Office Action Summary

10/711,177

DETAILED ACTION

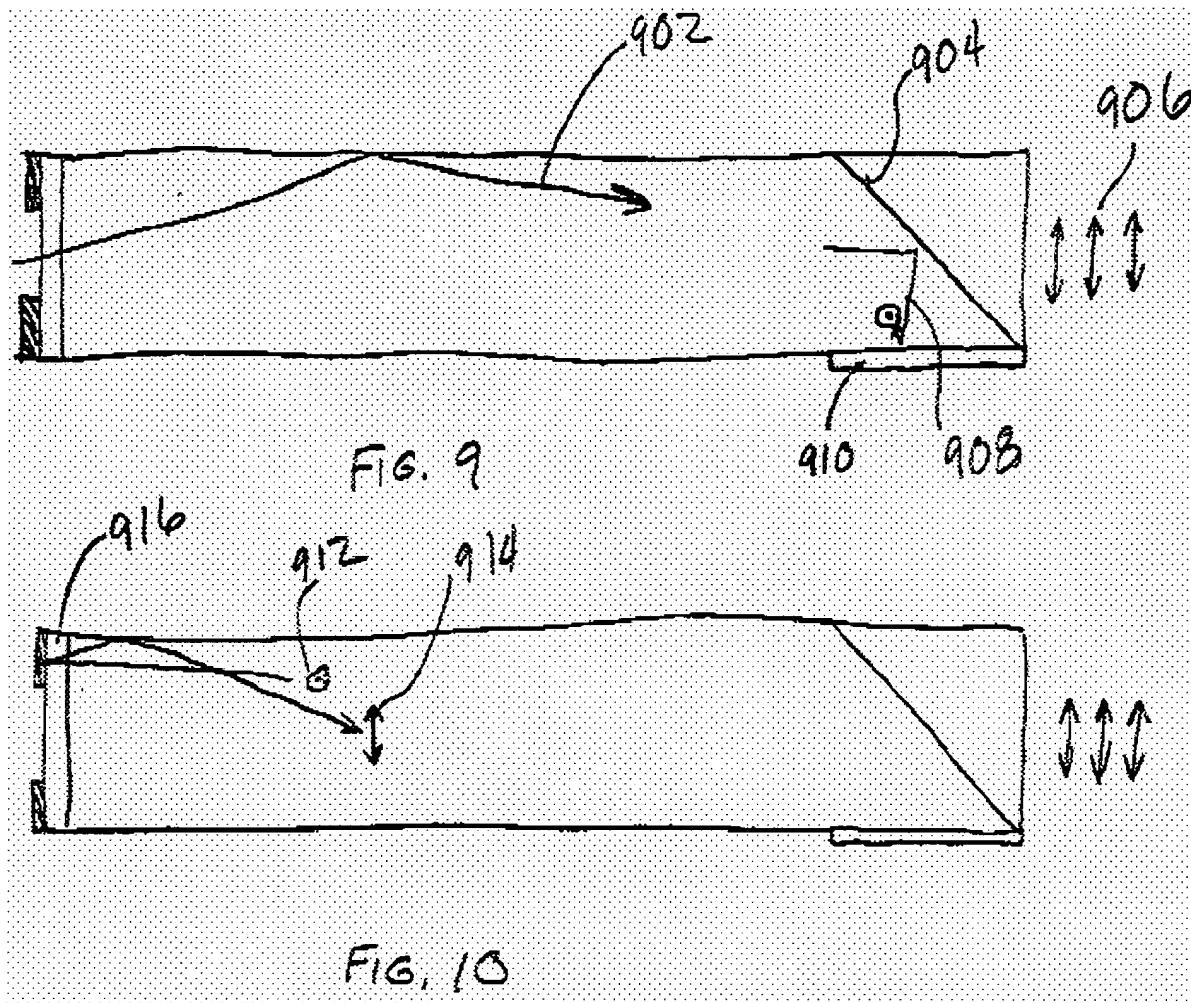
Regarding claim 1, Dewald discloses a polarization conversion light pipe device (Figures 9-10) comprising:

An integrating rod defined by four side reflective mirrors, wherein the light tunnel has a rectangular cross-section and has a light entrance face and a light exit face (see paragraph [0045]);

A front reflective mirror 302 (not labeled in Figures 9-10) mounted at the light entrance face with an aperture [0042];

A retardation plate 916 situated within the integrating rod;

A polarizing beam splitter 904 that is substantially 45 degree-inclined with respect to one of the side reflection mirrors, and is located with the light tunnel between the retardation plate 916 and the light exit face. Figures 9 and 10 of Dewald are reproduced below.
